PTS STANDARDS - 100 SERIES DRAWINGS
STANDARDS FOR ROADWAY CONSTRUCTION
APRIL 2022 EDITION – CHANGE NO. 2 – NOVEMBER 2023

PTS – 100 SERIES DRAWINGS

PENNSYLVANIA TURNPIKE COMMISSION
INDEX OF STANDARDS FOR ROADWAY CONSTRUCTION

PTS-122

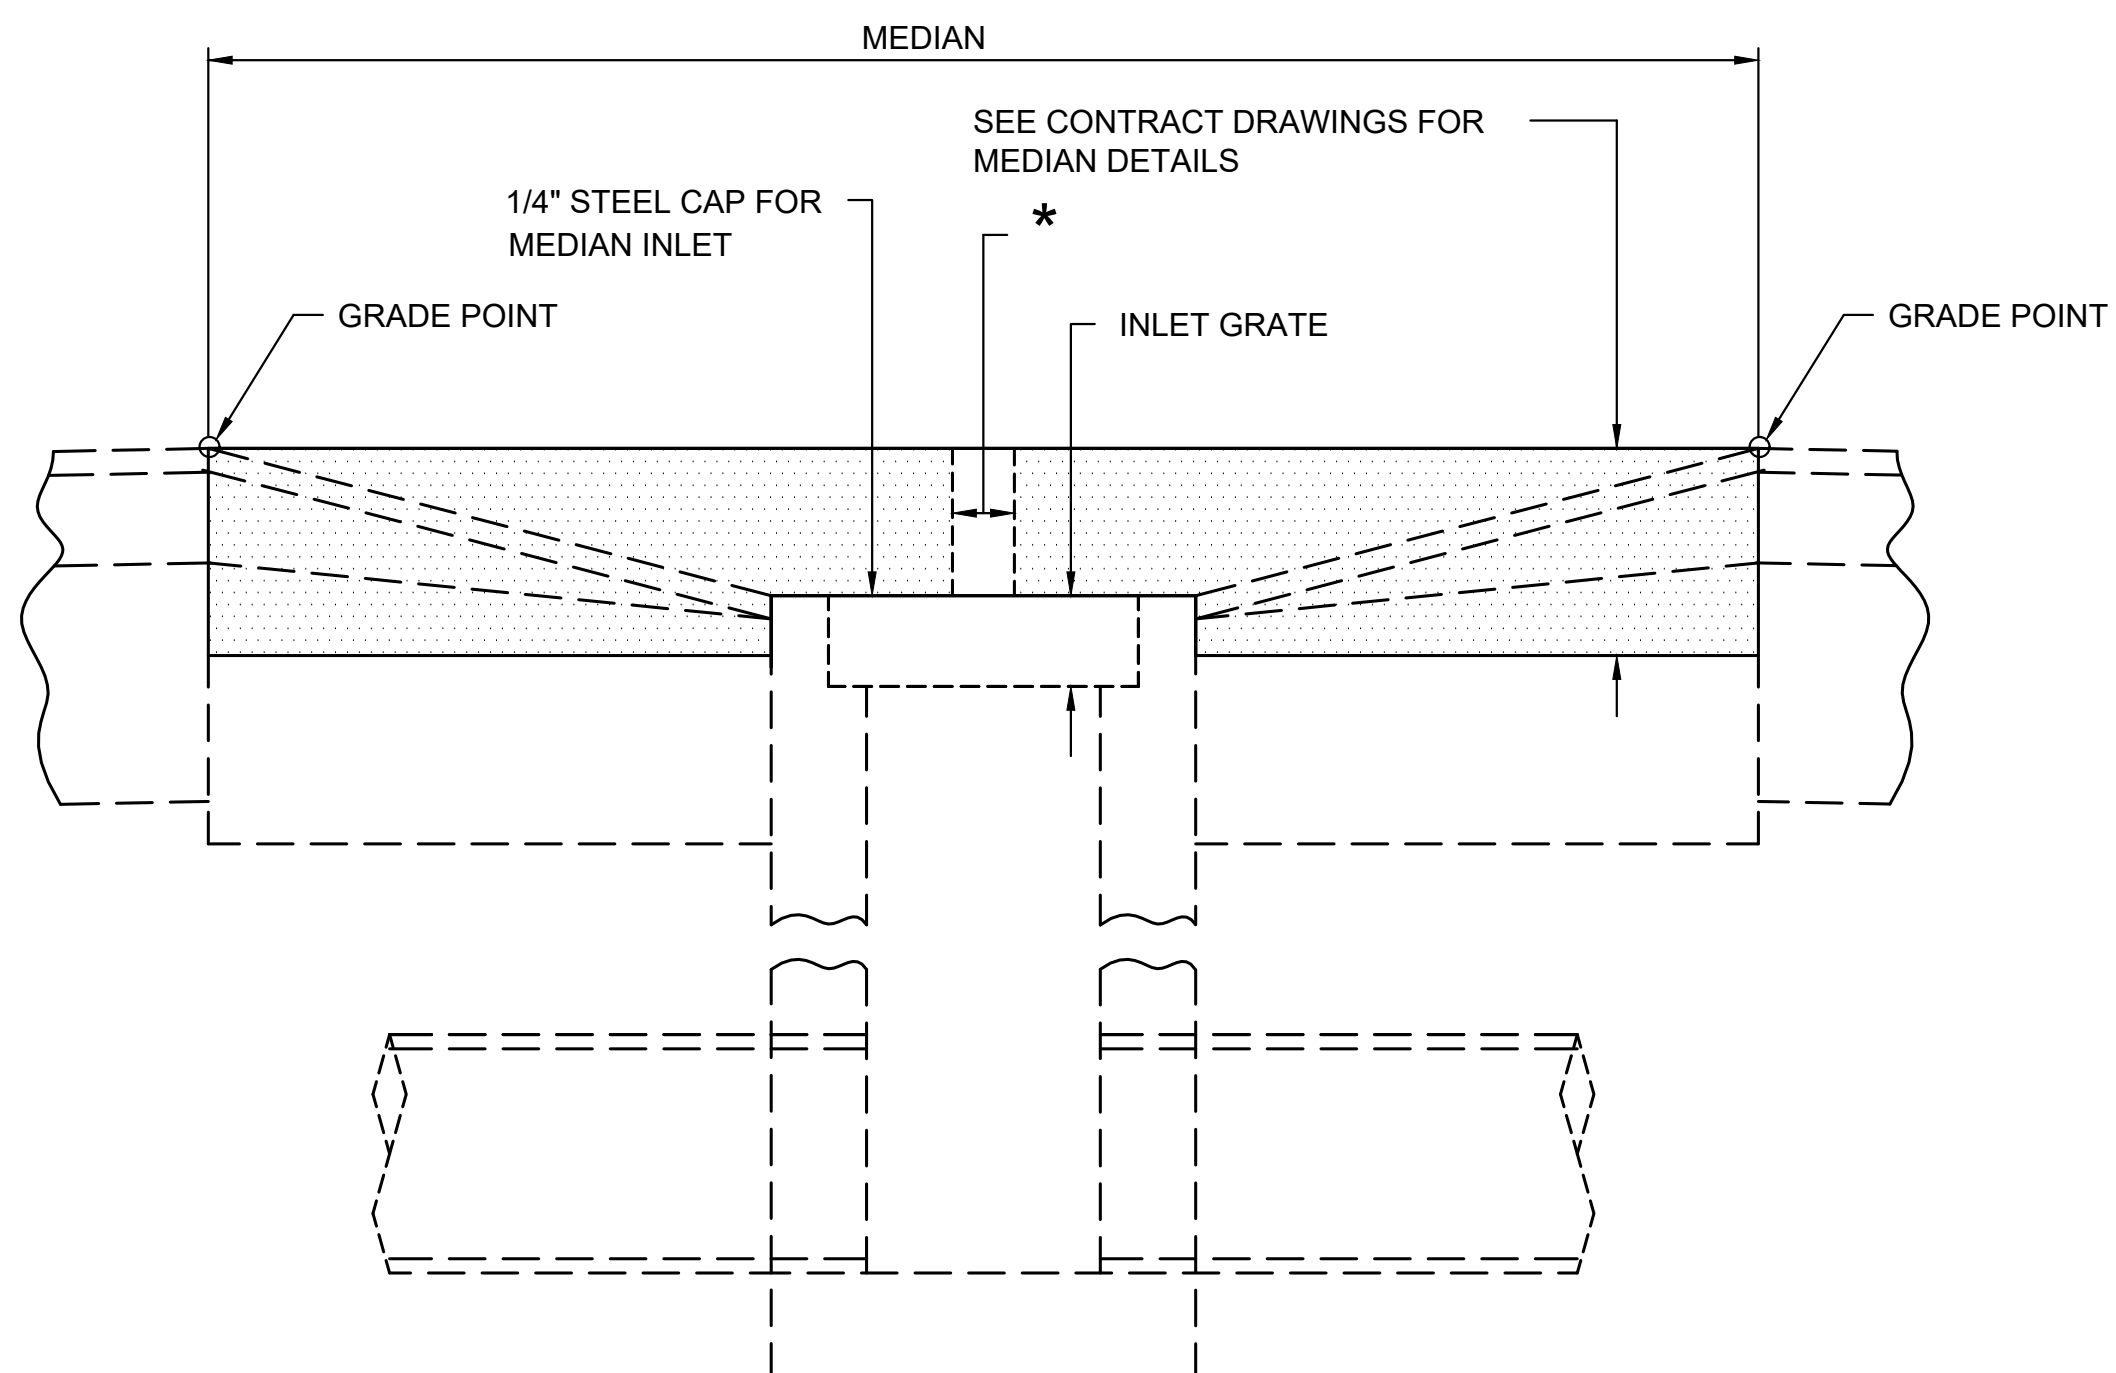
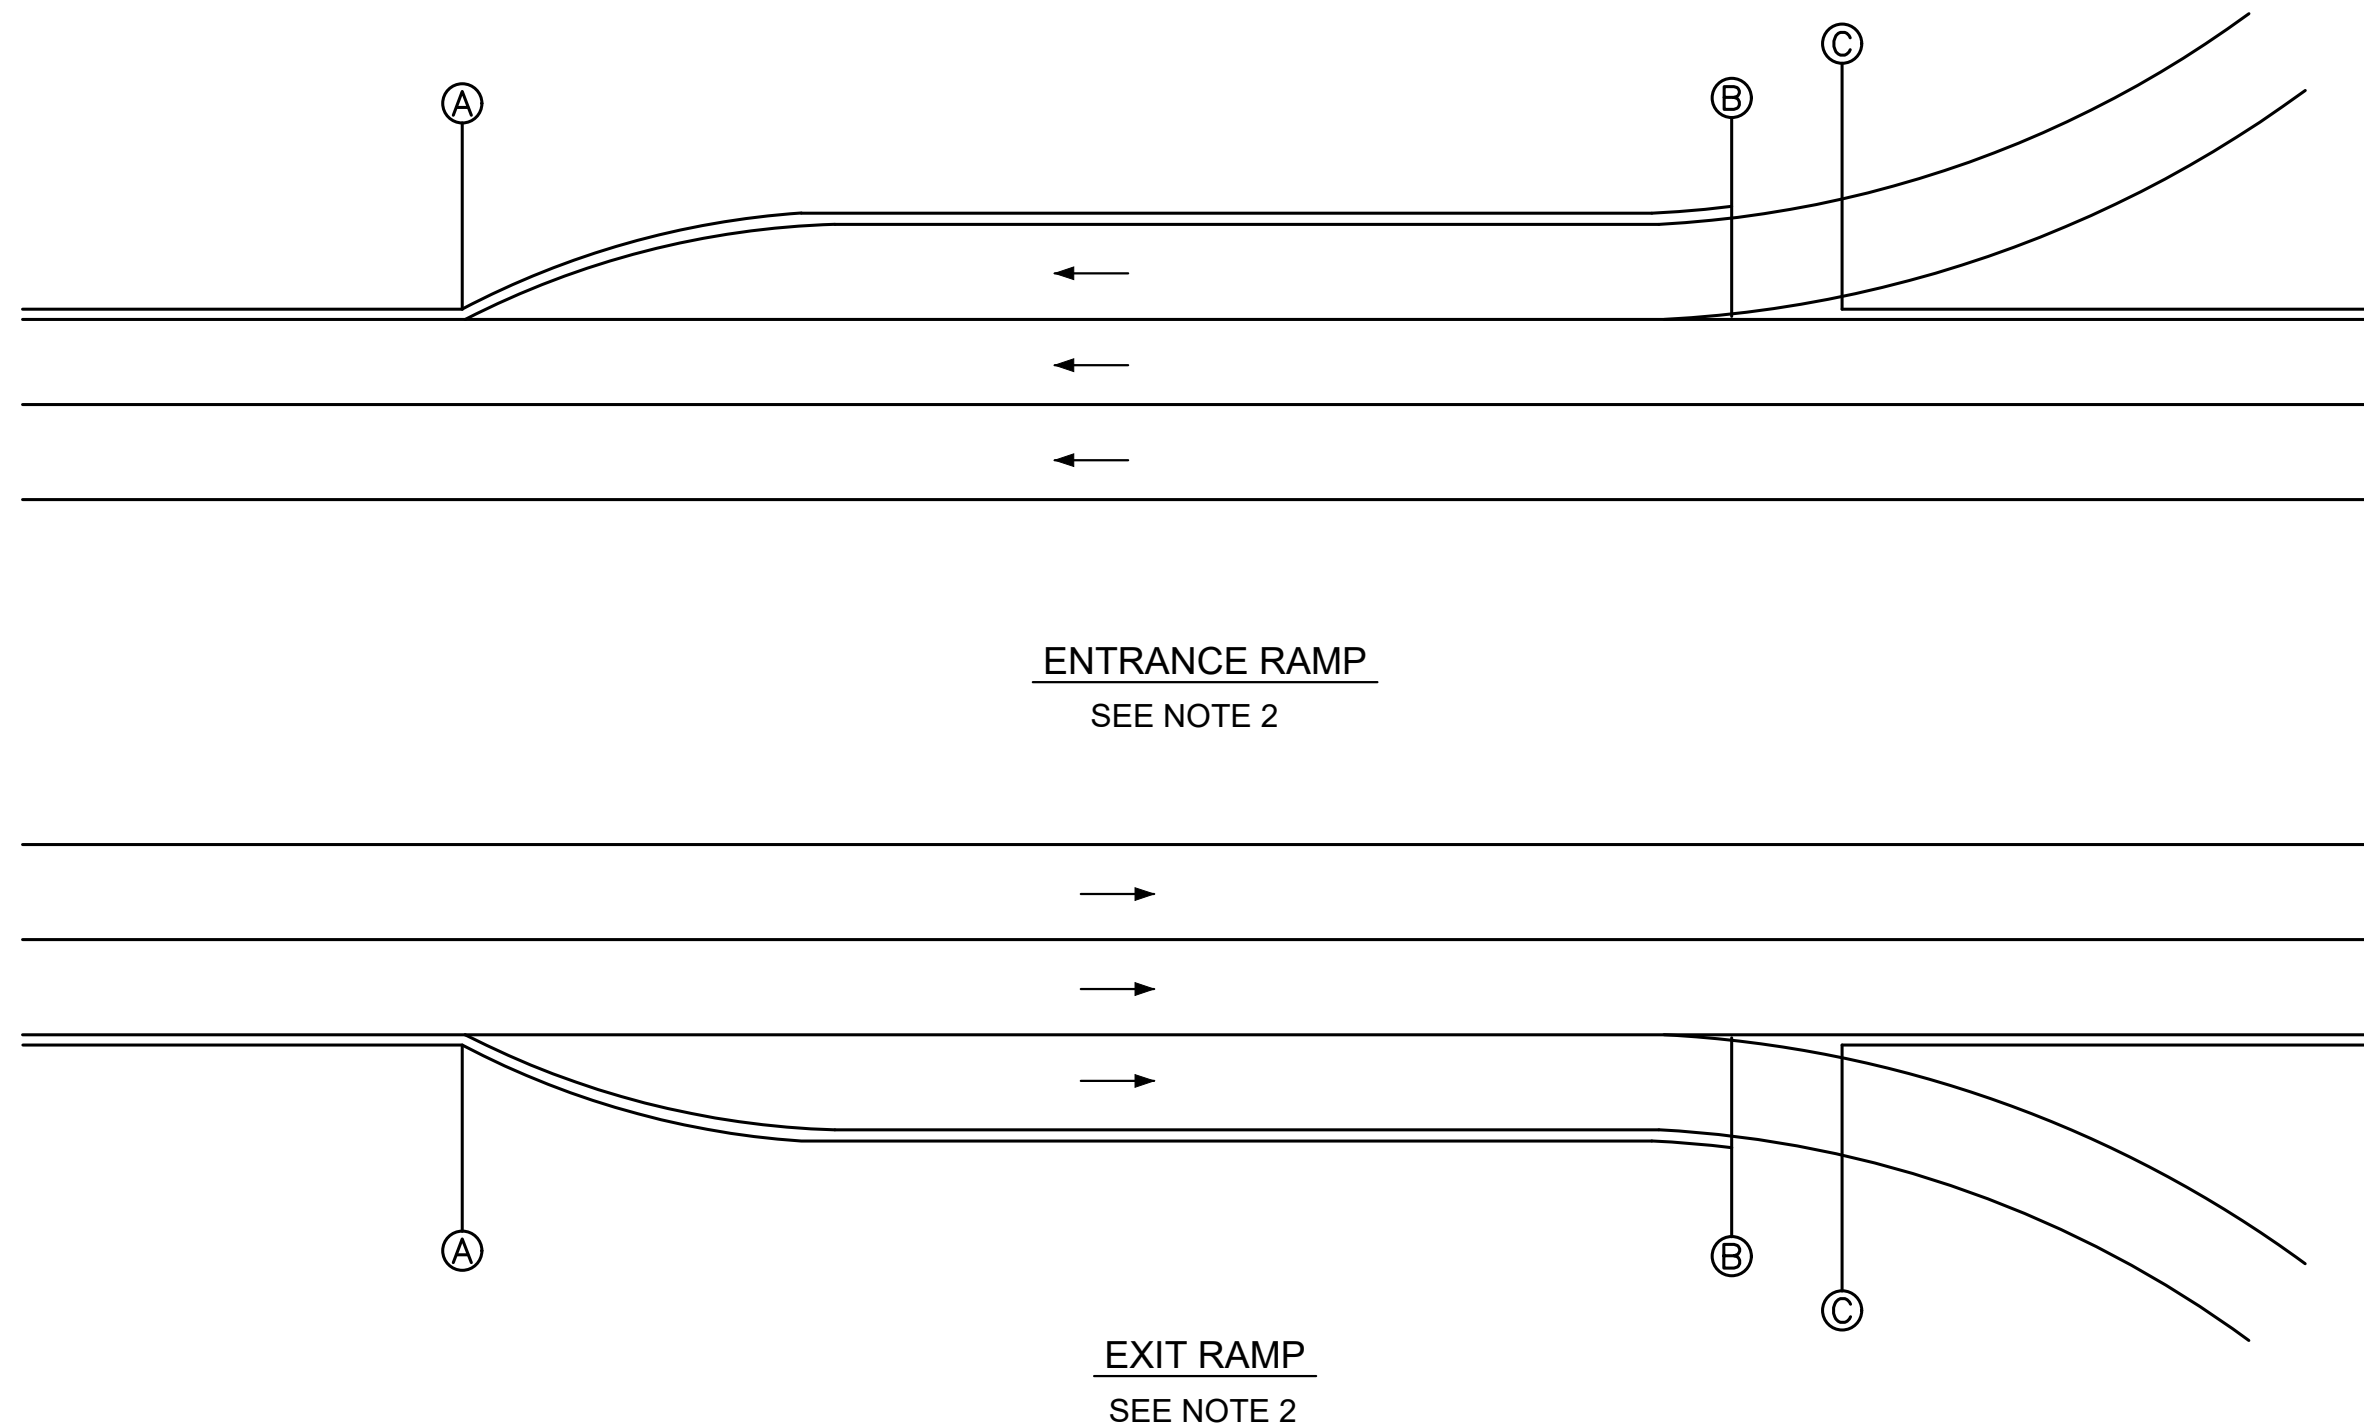
ADDED CALLOUT TO “REMOVE ANY BRICK”

RECOMMENDED: NOVEMBER 28, 2023	STANDARD DRAINAGE DETAILS	PENNSYLVANIA TURNPIKE COMMISSION STANDARD DRAWING	
			FILE NAME: PTS-124-1.dwg	SHEET 1 OF 6
	ASSISTANT CHIEF ENGINEER - DESIGN		DRAWING TYPE: 5A	
	APPROVED: NOVEMBER 29, 2023		DATE:NOVEMBER 2023	PTS-124
	 CHIEF ENGINEER

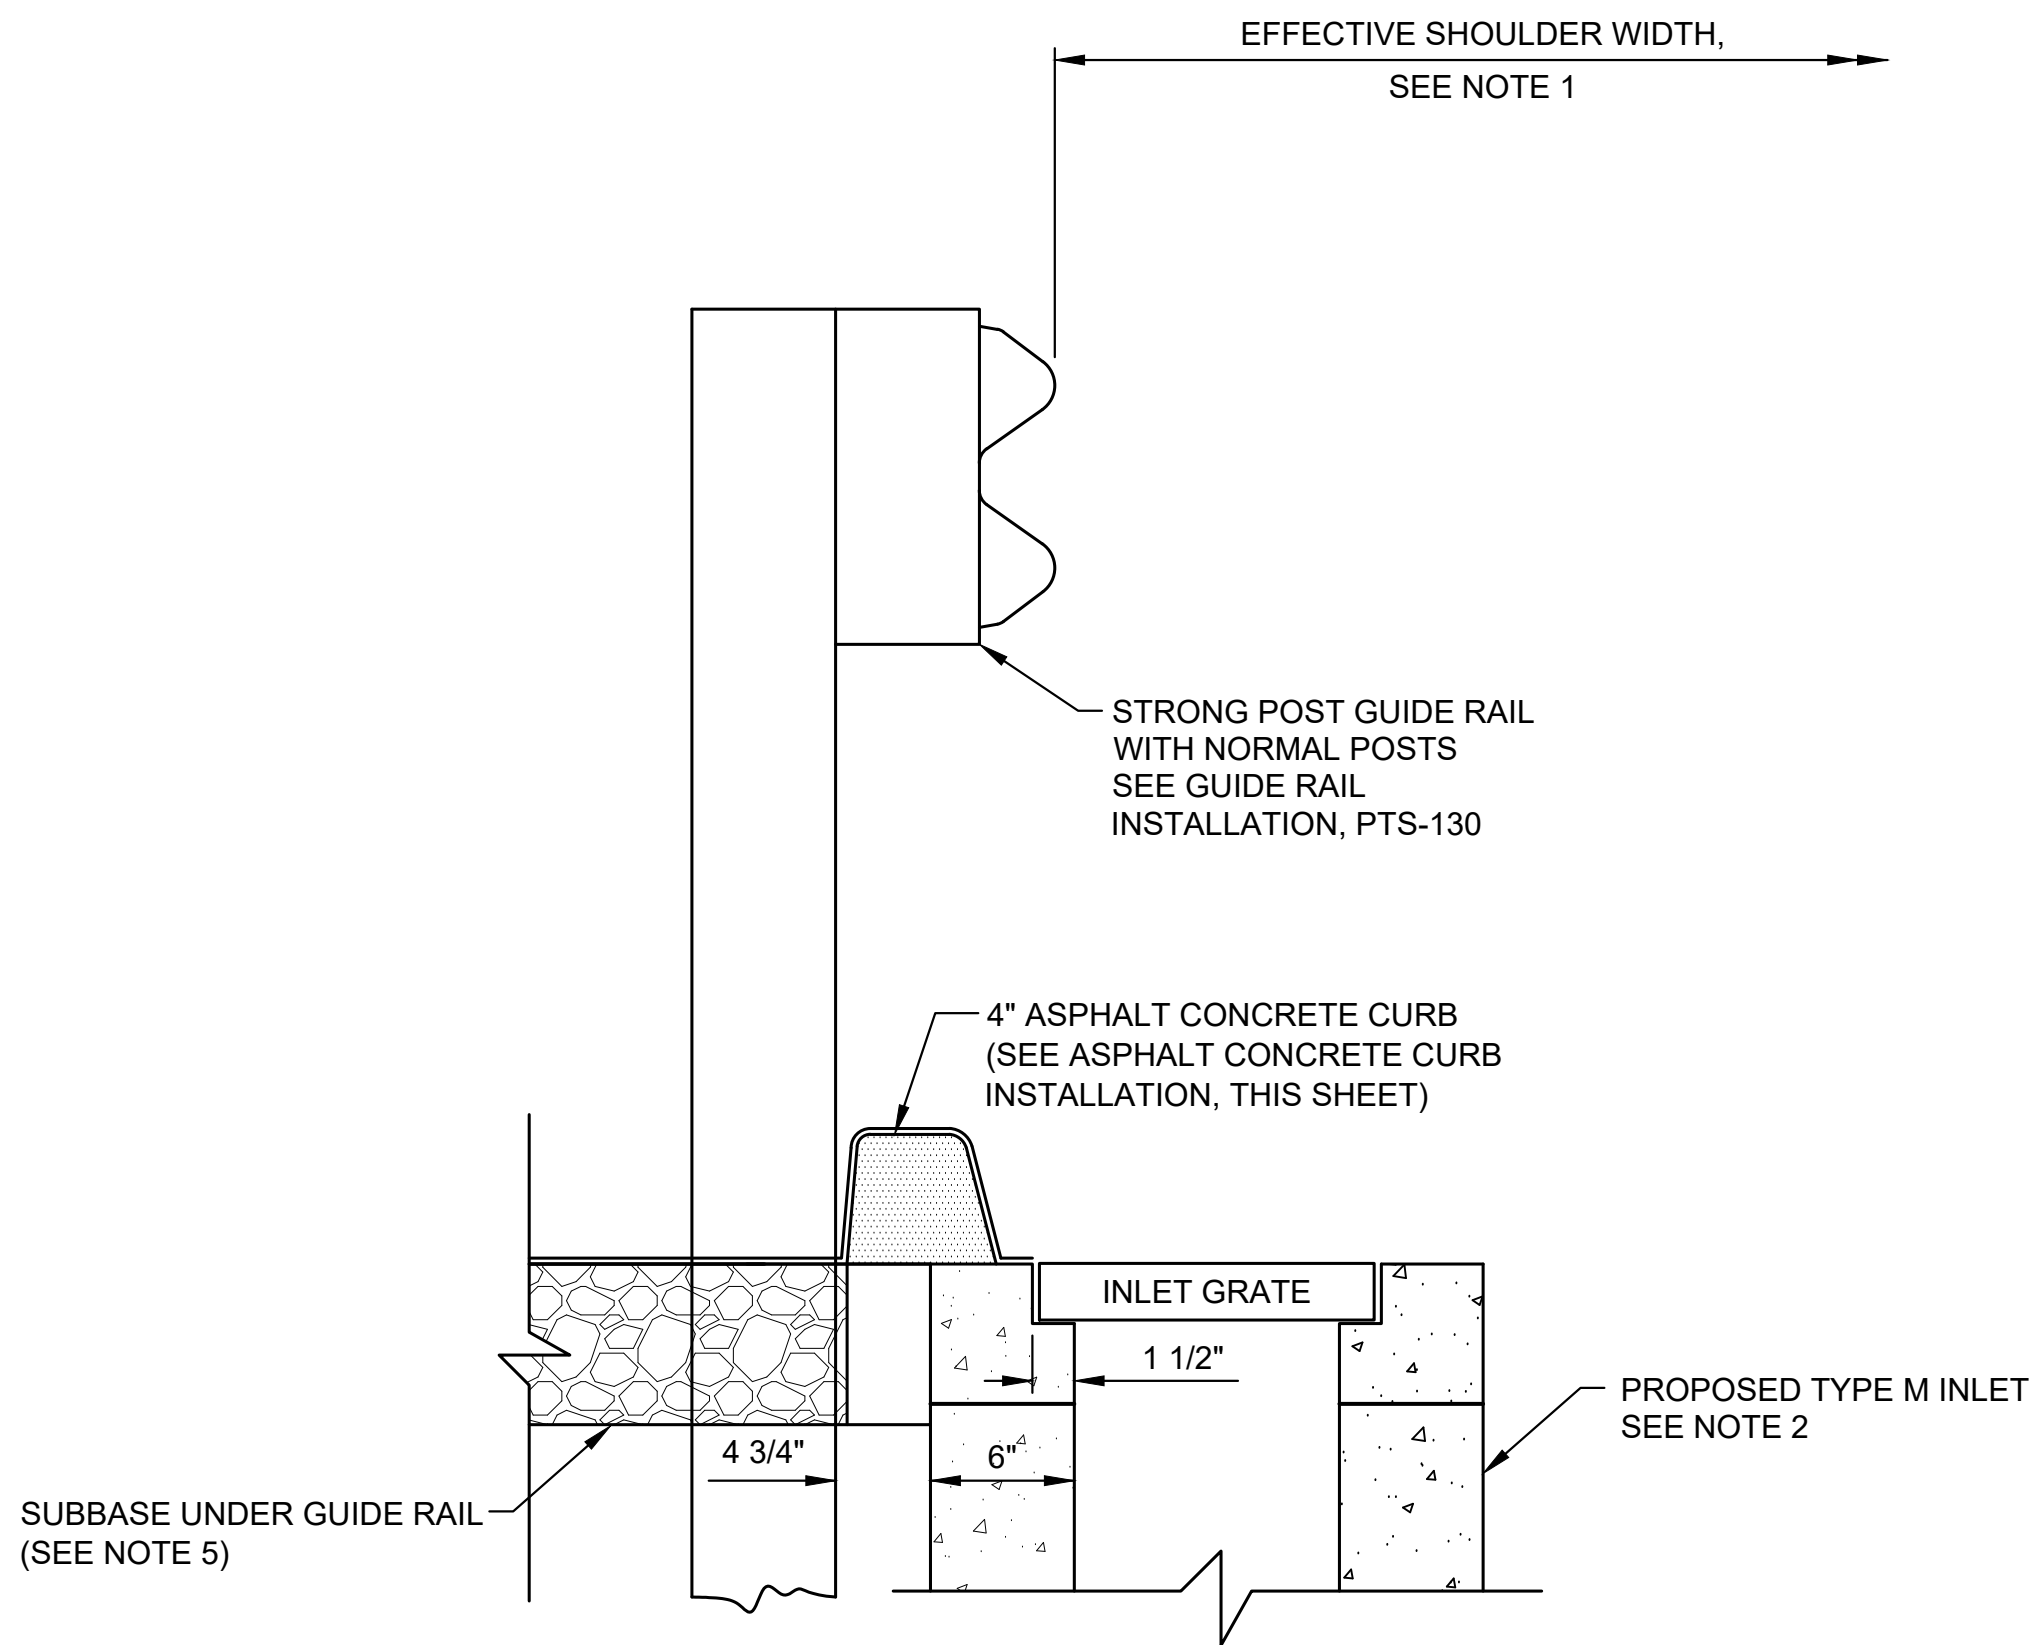
REVISED CALLOUT FOR SUBBASE UNDER GUIDE RAIL TO REFERENCE NOTE 5.
ADDED NOTE 5 “REFER TO PTS-130 GUIDE RAIL INSTALLATION – FILL CONDITION”.
